GROUNDWATER FLOW AND SOLUTE TRANSPORT MODELLING TO EVALUATE DISPOSAL OF TAILINGS IN TOUQUOY OPEN PIT

Response to Regulator Comments Regarding Groundwater Modelling Update to Address November 5, 2020 Information Request from IAAC for the Beaver Dam and Fifteen Mile Stream Projects.

Figure 5.10 Sensitivity of Fracture Hydraulic Conductivity on Relative Concentrations in Moose River

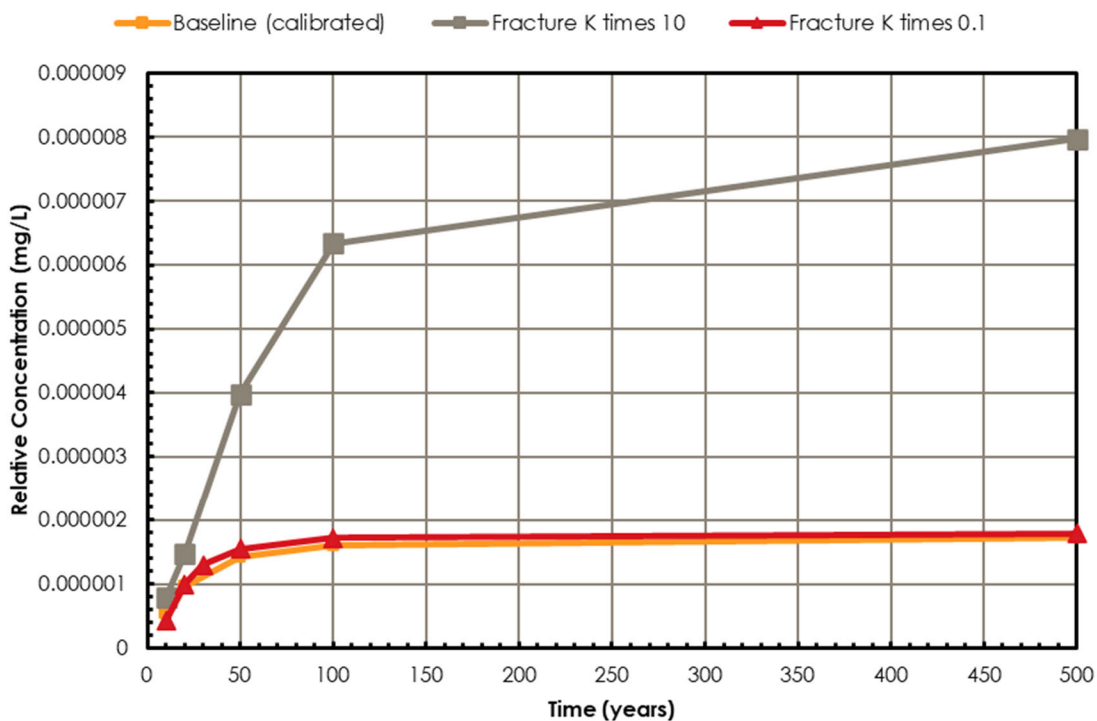
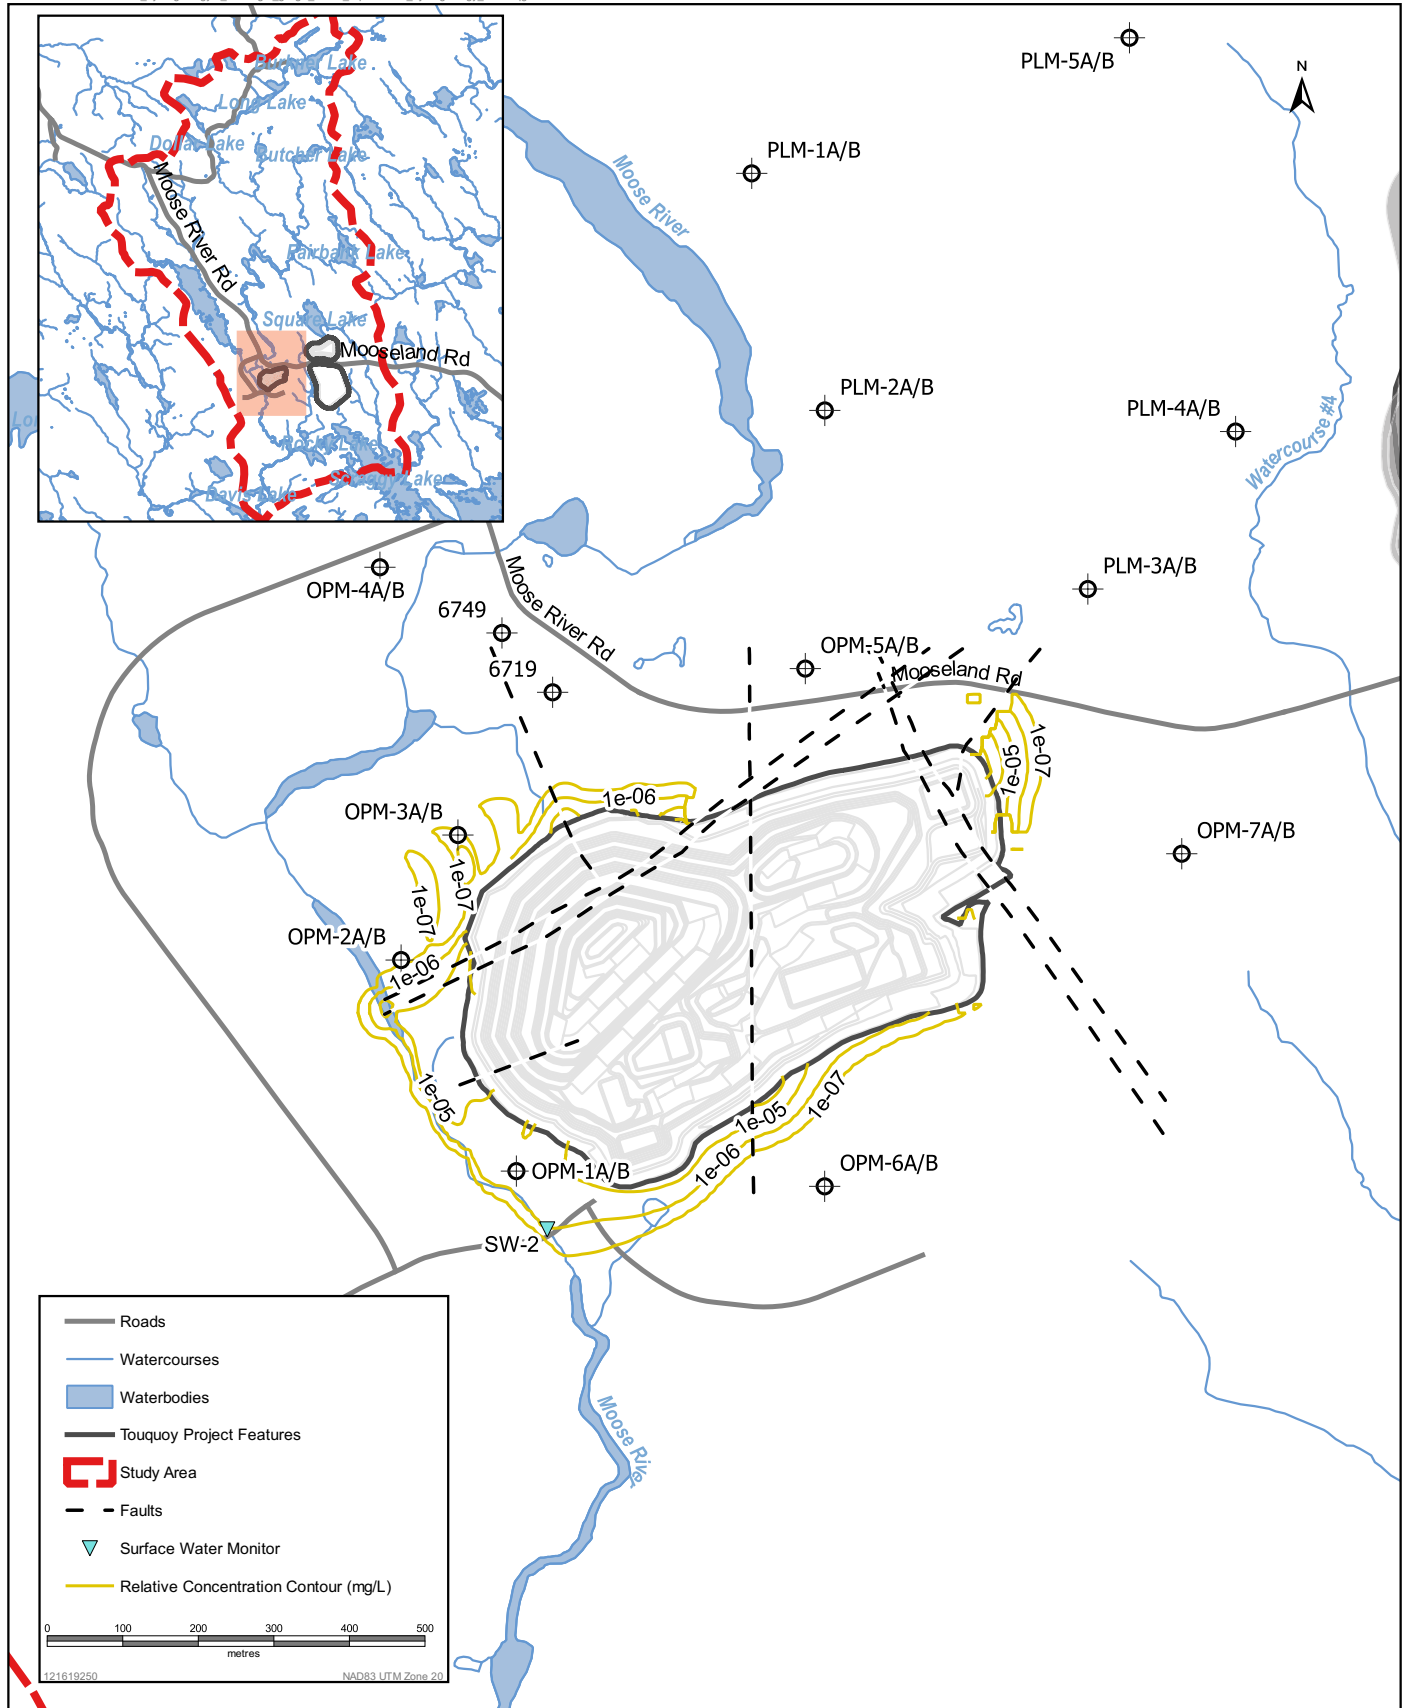
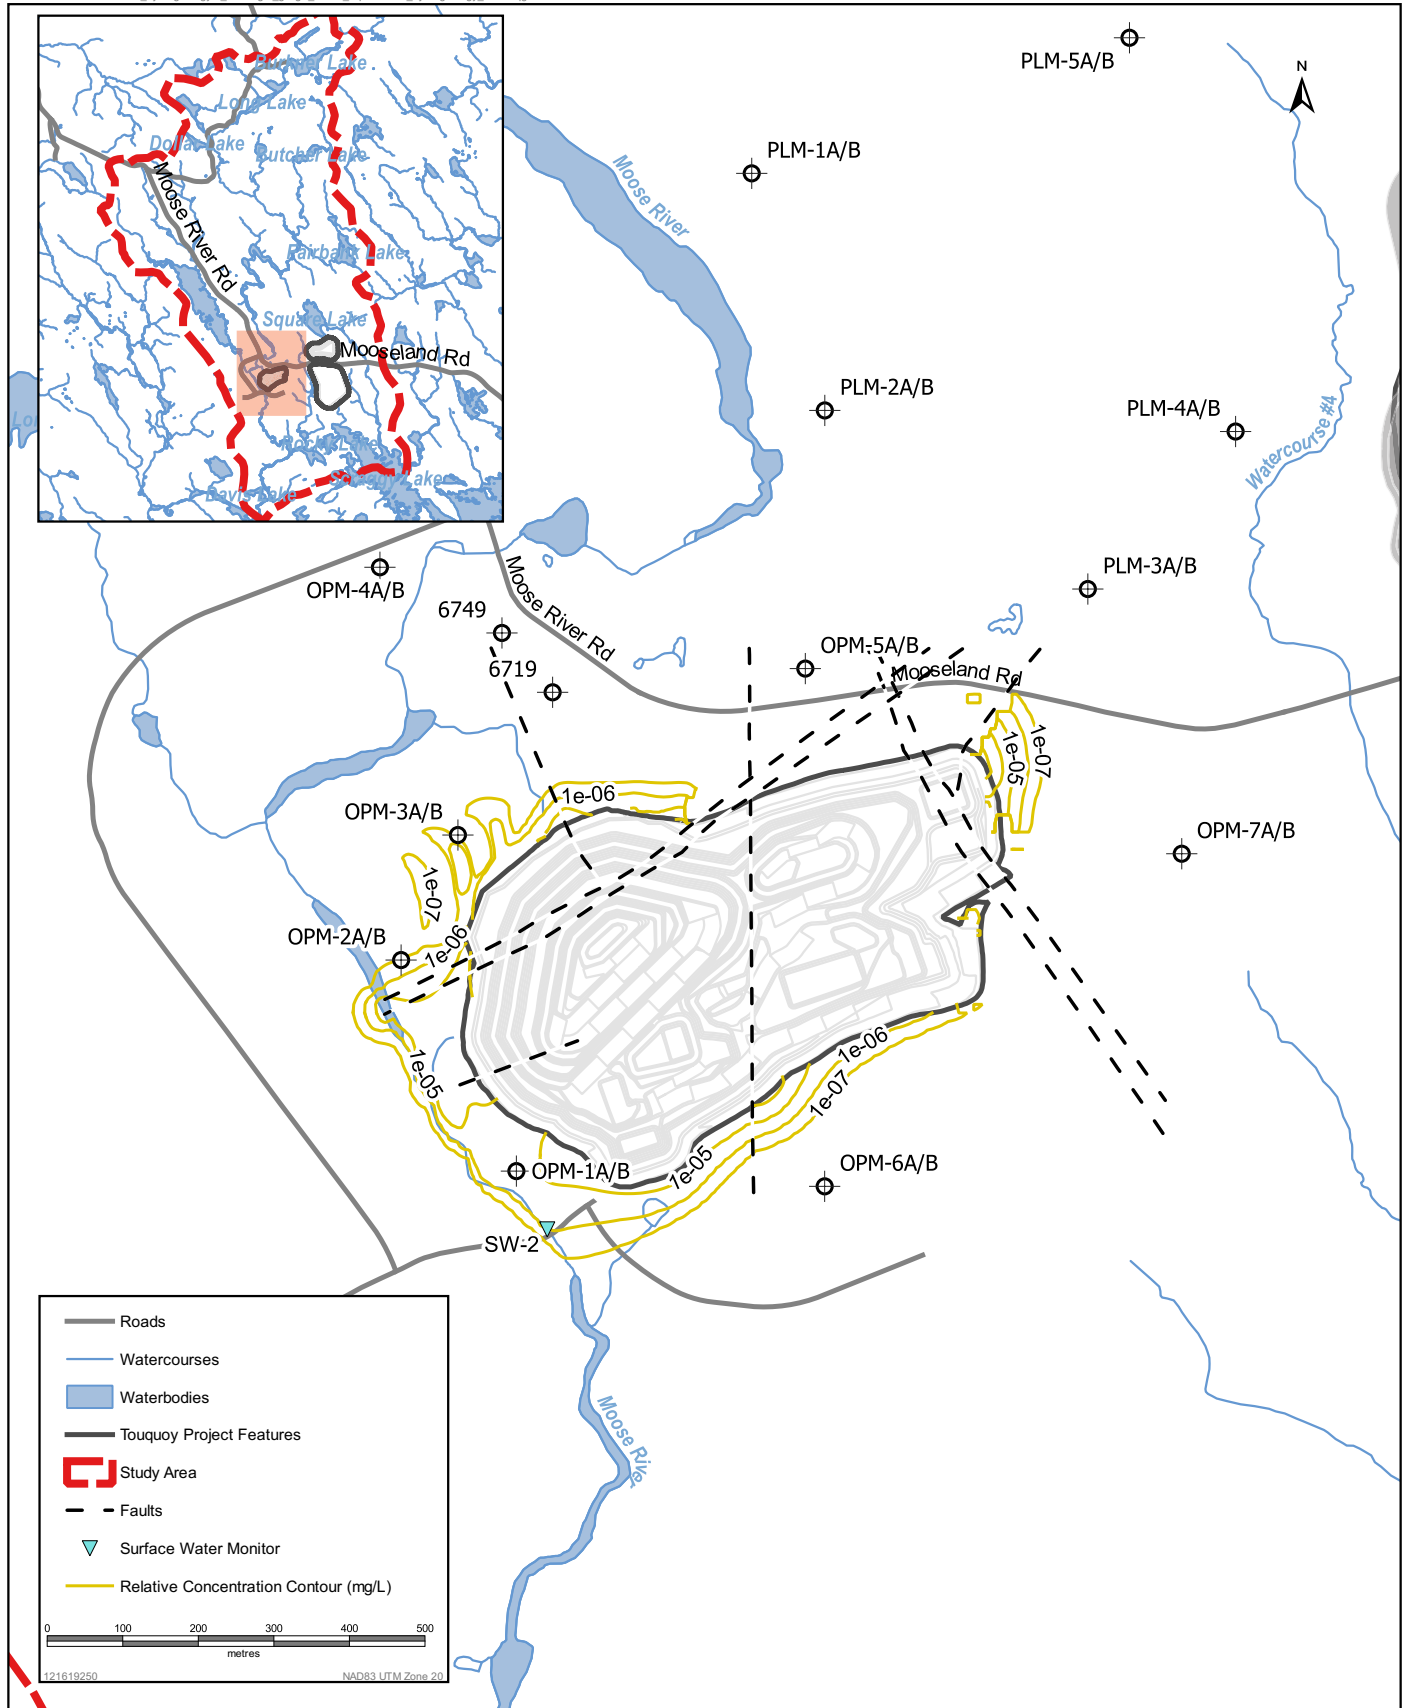
NRCan-15	<p>Section 2.0 Task 2 – re: “Additional model runs...”:</p> <p>Faults impact: Given that no field work can support the role of the faults, a conservative scenario with high permeability faults should be used.</p>	<p>This was the approach used in the previous modelling, and has been updated in Section 5.4.2.1 of the current report.</p>

Figure 5.13 Sensitivity of Bedrock Porosity on Relative Concentrations in Moose River

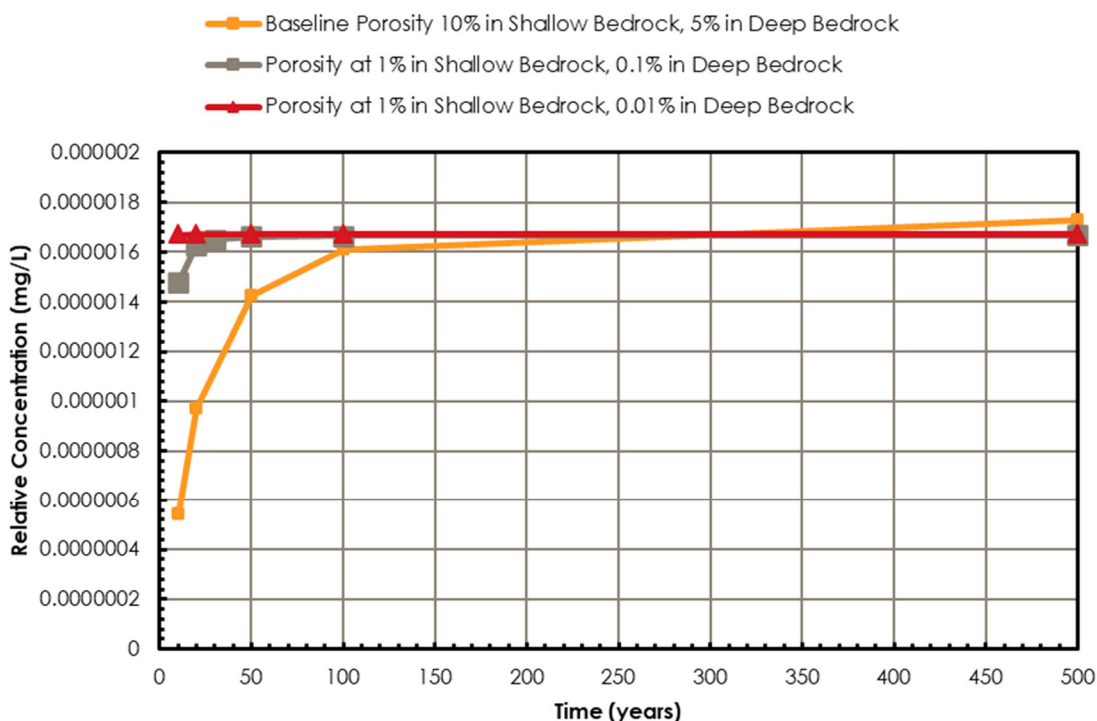
Item	Comment	Response
NRCan-14	<p>Section 2.0 Task 2 – re: “transport simulations”:</p> <p>Numerical dispersion: Appropriate cell size in the region between Moose River and the pit should be used to avoid numerical artifact in the transport simulations. See previous comment.</p> <p>Effective porosity: Porosity is also important for transport simulations. Large porosities will accumulate mass in the aquifer and delay migration times. The opposite for low porosity values. What is the supporting information for porosity? Porosity should be also included in the sensitivity simulations.</p> <p>Effective porosity: Moreover, porosity values reported in I4 seems to reflect total porosity. For transport simulation, effective porosity should instead be used. Effective porosity is generally much lower than total porosity. Especially in bedrock formations where much of the pores are not interconnected and an important proportion of water is not contributing to flow (stagnant water). To be conservative, without field/lab support, effective porosity values on the lower-end range of reported values in the literature should be used.</p>	<p>A sensitivity analysis for the effects of porosity on transport runs is provided in Section 5.4.2.2.</p>
